MEMORANDUM

FROM: Jennifer Sukow, IDWR

DATE: October 31, 2012

RE: Mud Lake perched seepage, pumping, and diversion data for ESPAM2.1

Figure 1.

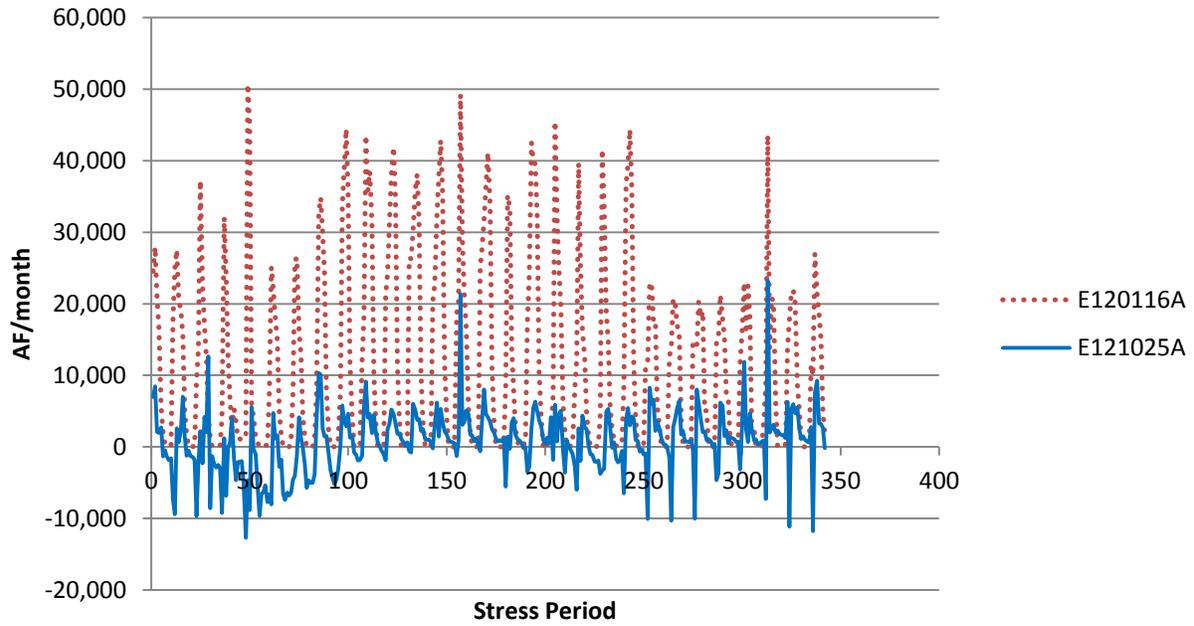
1. Mud Lake seepage was calculated using inconsistent units. IESW029 diversions and change in Mud Lake contents were in units of AF/month, while all other values were in ft³/month.
2. B31 flood control diversions were added to, rather than subtracted from the seepage.
3. The volume of well water pumped into Mud Lake was about twice the volume recorded by the Water District 31 Watermaster for most years between 1980 and 2000. This is likely the result of assuming that values reported by the Watermaster were in 24-hr cfs when they were actually reported in AF.

1. Perform calculations using consistent units.
2. B31 flood control diversions should be subtracted during calculation of Mud Lake seepage.
3. Replace 1980 through 2000 data for Mud Lake well pumping, IESW029 diversions, Camas Wildlife Refuge seepage, and B31 flood control seepage with monthly data obtained from Watermaster records.

Figure 2.

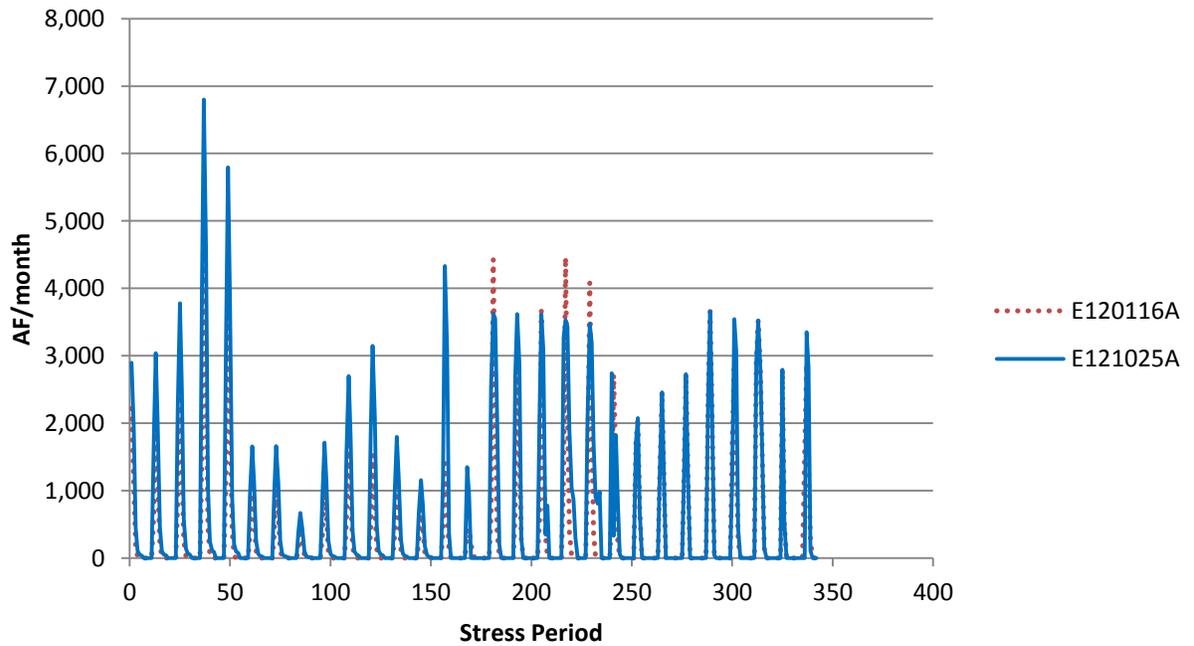
1. Monthly values for IESW029 diversions, Camas Wildlife Refuge seepage, and B31 flood control seepage are not consistent with Water District 31 Watermaster records for 1980 through 2000. The values for these years were based on annual diversions shaped by average monthly distributions, rather than monthly data recorded by the Watermaster. Monthly values for Camas Wildlife Refuge seepage are also not consistent with Watermaster records for 2005 and 2008.

Figure 6.

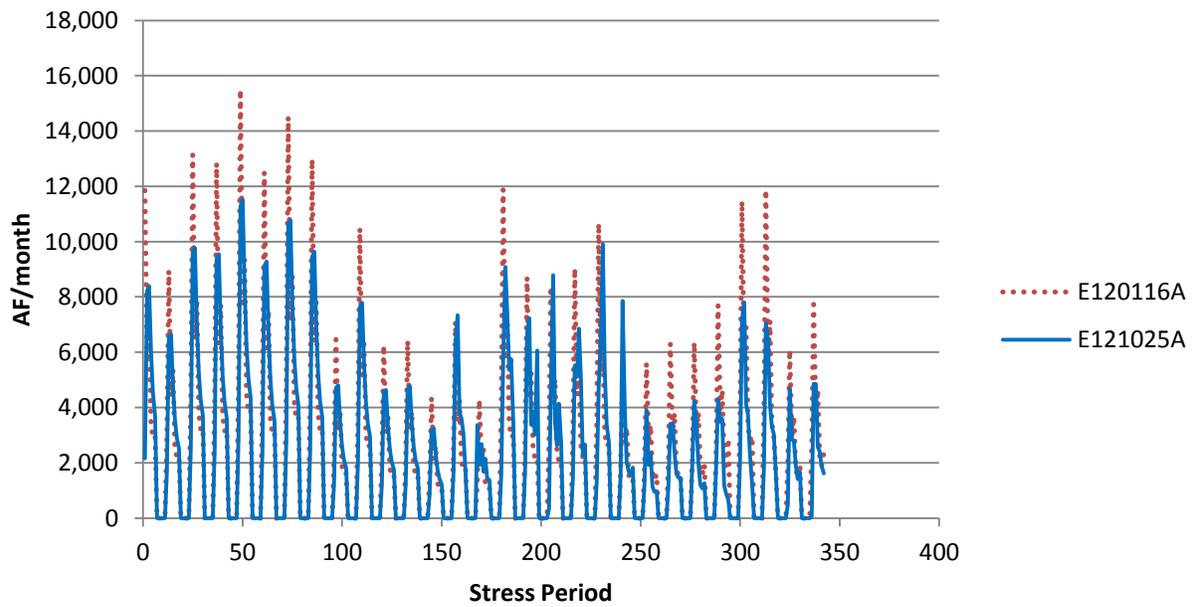
2. Monthly values for IESW051 (Dubois) diversions are not consistent with Water District 31 Watermaster records for 1993 through 2010. The values for 1980-2000 were based on annual diversions shaped by average monthly distributions, rather than monthly data recorded by the Watermaster, which are available for 1993-2010. The values for 2001-2010 included Camas Wildlife Refuge diversions, which are input into ESPAM as perched seepage at Camas Wildlife Refuge and should be excluded from IESW051 diversions.

4. Replace 1993 through 2010 data for IESW051 diversions with monthly data obtained from Watermaster records. Exclude Camas Wildlife Refuge diversions for all years.

5. Exclude Camas Wildlife diversions from IESW051 diversions for all years.
6. For 2002 through 2010 Mud Lake well pumping data, assume that 20% of pre-May 1 pumping occurs in March and 80% occurs in April, rather than $\frac{1}{2}$ in March and $\frac{1}{2}$ in April. The revised apportionment is based on seven years with recorded pumping volumes for March and April.

Figure 7.

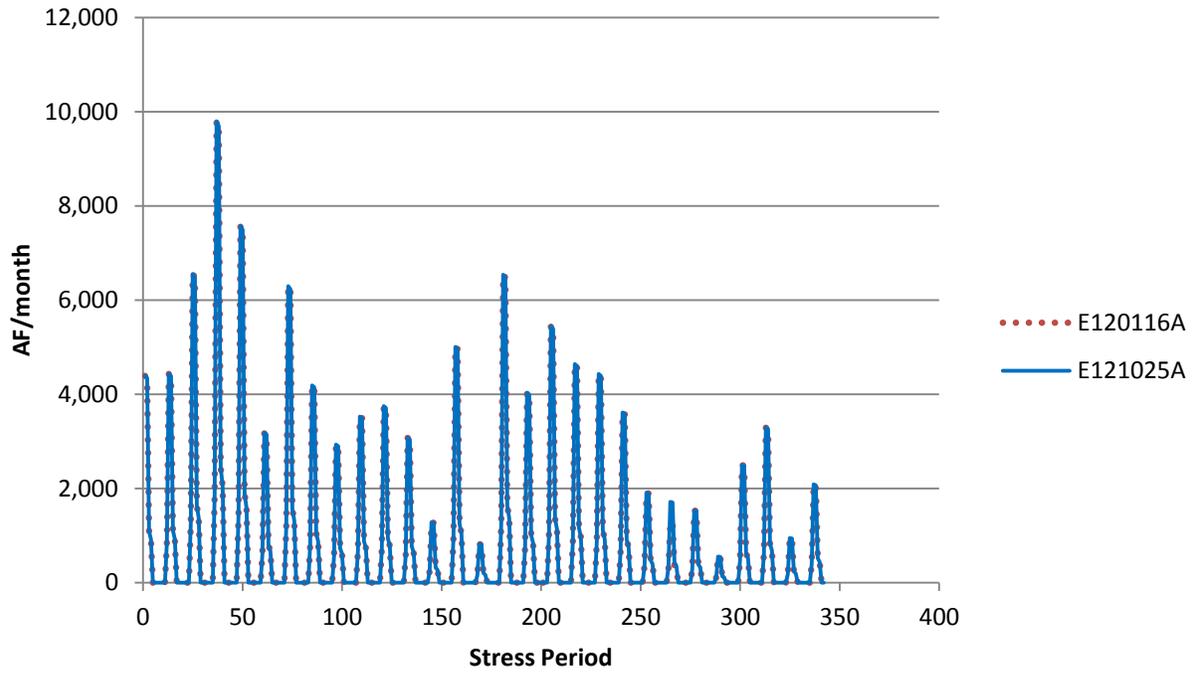
9. Replace Mud Lake well pumping data set in FPT file.
10. Revise data sets for which minor discrepancies were found by IWRRI after calibration of ESPAM2.0 was completed (Figures 7 through 14).

- a. Replace average values used for 1980-2001 diversion data for IESW051 and 2002 diversion data for IESW008 with actual data from Water District 33 records (DIV file).
